From: Sean Gartner
Sent: 18/07/2024 4:31:50 PM
To: Stephanie Gelder
Cc: Council Northernbeaches Mailbox; mattd@braeton.com.au
Subject: TRIMMED: Objection to REV2024/0020 - 955 Barrenjoey Road, Palm Beach
Attachments: 2403_objection to 955 Barrenjoey(REV2024-0020).pdf;

Objection to REV2024/0020

Alterations and Additions to a Dwelling House at 955 Barrenjoey Road, Palm Beach

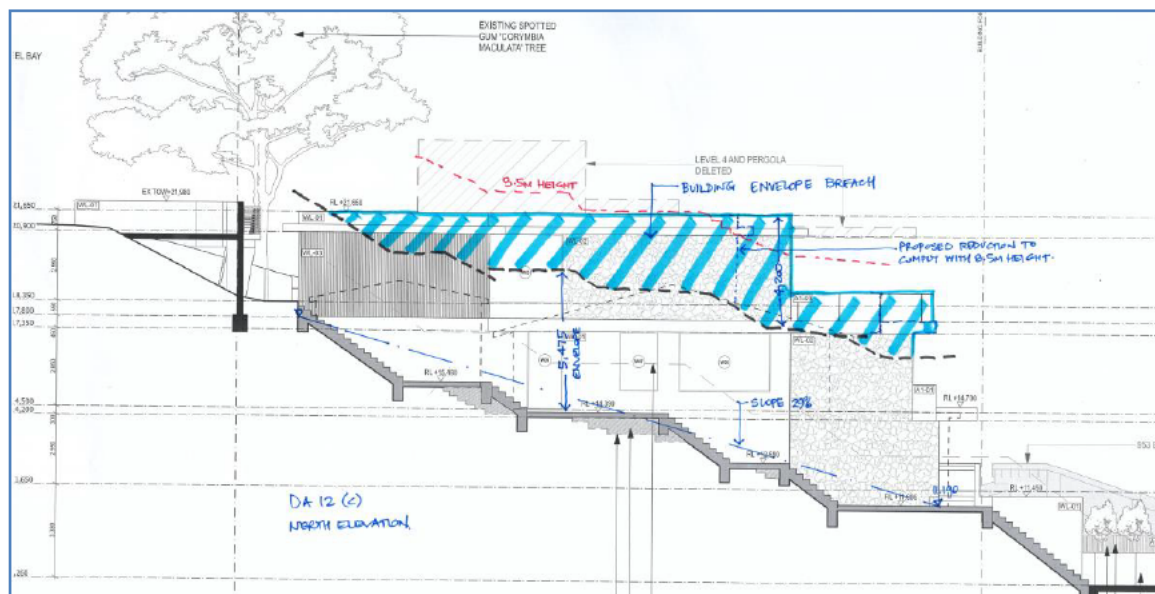
The proposed terrace of 955 is 5.1m wide and directly overlooks the principle private open space of the Living room and deck off the living room of 959 with a separation distance of 3.5m. It also looks directly into the main bedroom, deck off the main bedroom and ensuite to the main bedroom on the upper floor. The s8.2 has removed that previously proposed landscape in planters for privacy and fails to recognise the DCP requirements above.

The design of the proposed terrace is attempting to achieve NW views at the expense of privacy to 959. The Terrace of 955 is elevated above the living area and deck of 959 and does not propose any privacy screens and will overlook more than 50% of the private open space of 959.

The proposal fails to comply with the controls and the impact upon the privacy to 959 is unreasonable and unacceptable. The impact is exacerbated by the non-compliance with side boundary envelope to the terrace.

The proposal should be refused for non-compliance with visual privacy.
